RE: Comments on the Fenway Point Project

RE: PNF on "The Point"  
Brookline Avenue and Boylston Street  
Boston

The following presents a copy of each comment letter received by the Boston Redevelopment Authority (BRA) during the public review period for the ‘expanded’ Project Notification Form (PNF), which was filed on February 15, 2013. Each comment letter received is listed in Table 1 below.

Plan of Taking From  
City of Boston Parks Department and  
City of Boston Department of Public Works

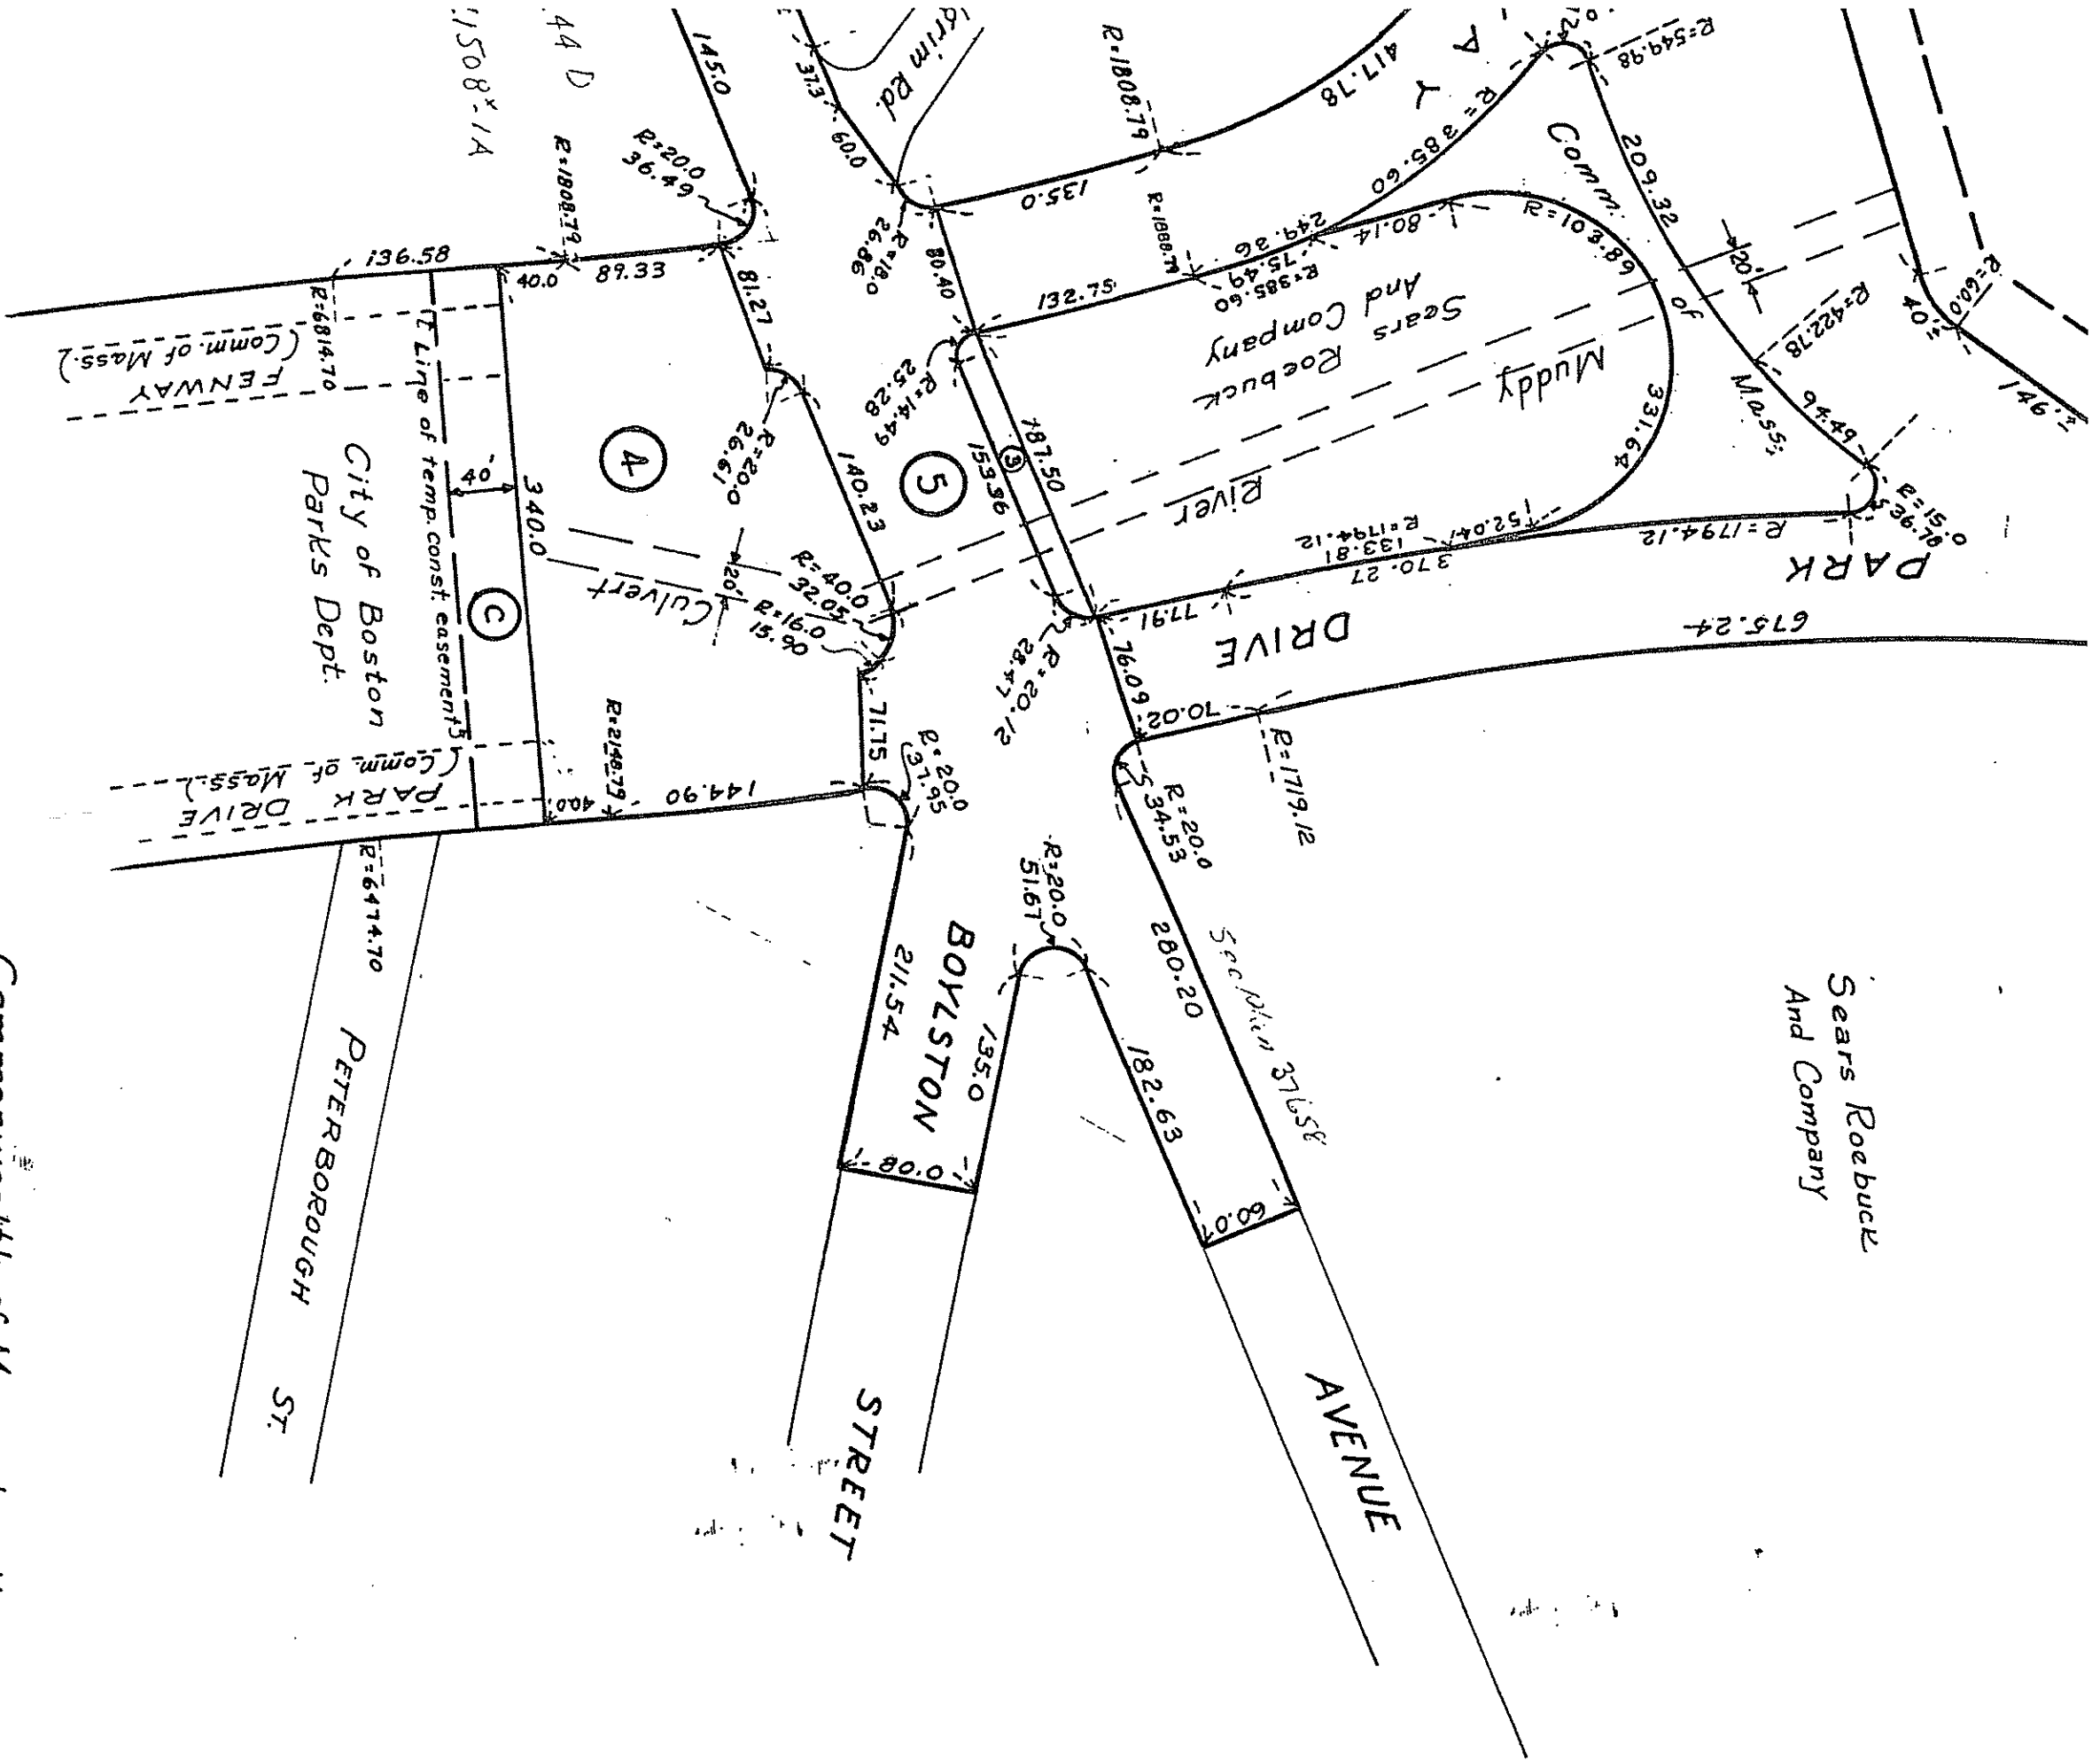
It's clear from the 1959 Takings Plan (see attached) that DCR owns the right of way immediately adjacent to the project area on both Brookline Avenue and Boylston Street. The project team should confirm the precise limits of the *parkway* with DCR to ensure that the project is in compliance with the height restrictions adjacent to parkways.

Plan of Taking From  
 City of Boston Parks Department and  
 City of Boston Department of Public Works

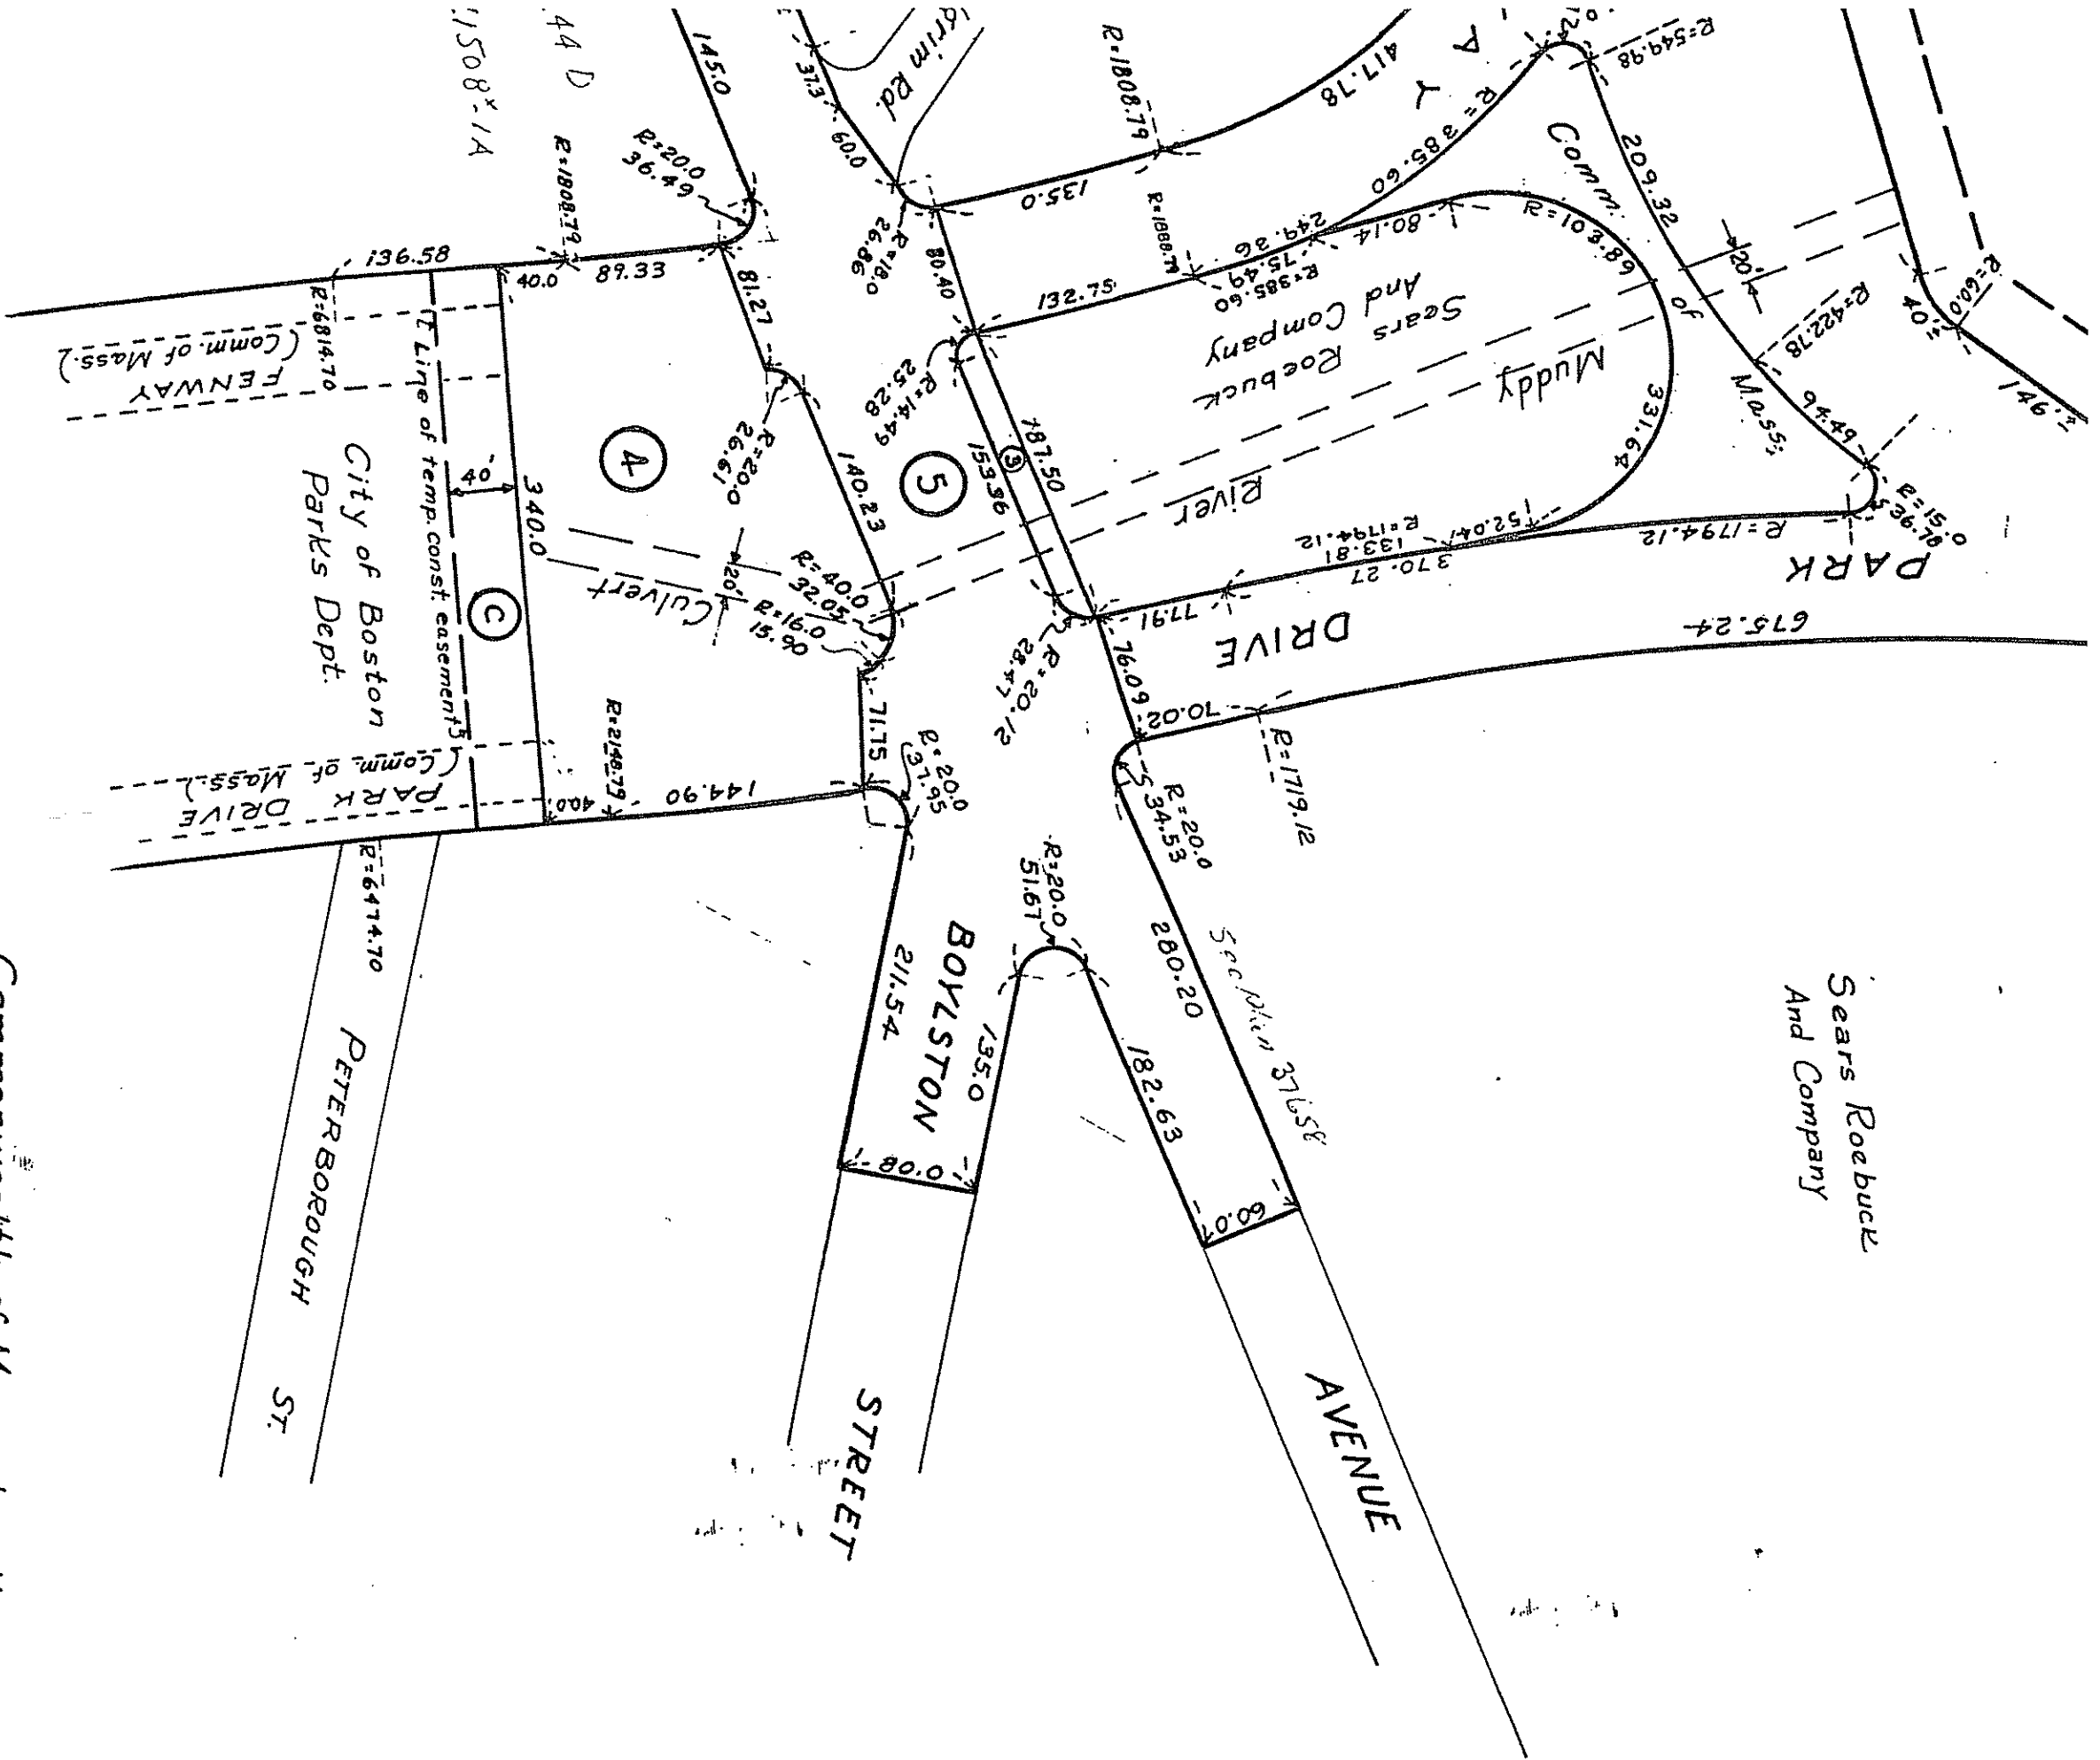
It's clear from the 1959 Takings Plan (see attached) that DCR owns the right of way immediately adjacent to the project area on both Brookline Avenue and Boylston Street. The project team should confirm the precise limits of the *parkway* with DCR to ensure that the project is in compliance with the height restrictions adjacent to parkways.

*“It’s clear from the 1959 Takings Plan (see attached) that DCR owns the right of way immediately adjacent to the project area on both Brookline Avenue and Boylston Street. The project team should confirm the precise limits of the parkway with DCR to ensure that the project is in compliance with the height restrictions adjacent to parkways.”*
